Examiner 1: Corrections Report:

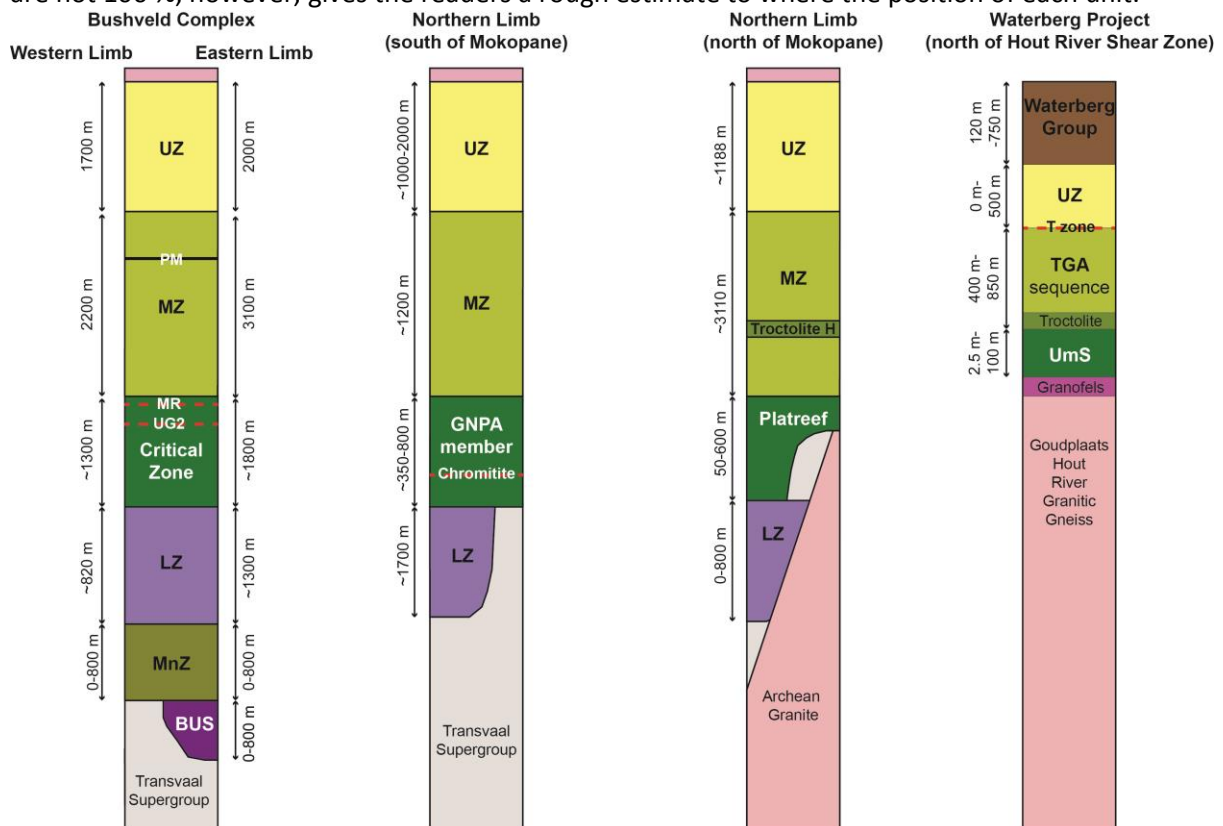
Examiner: Page 238, Figure 9.1: The depths and positioning of the horizons within zones in this diagram is incorrect. The Main Zone in the Northern Limb north of Mokopane is much thicker than what you indicate. The position of the troctolite horizon within the MZ is also wrong. This Figure has to be fixed. Also, the caption should read: "...in the magmatic stratigraphy across..."

Response: Figure 9.1 has been edited to show that the Main Zone in the northern limb has a thickness of ~3110 m as suggested by the examiner and seen in Roelofse and Ashwal (2012), Ashwal *et al.* (2005) and Tanner *et al.* (2014). The position of the troctolite has been moved upwards as it is ~1000 m above the Platreef – Main Zone contact, this is a schematic diagram so the measurement are not 100 %, however, gives the readers a rough estimate to where the position of each unit.
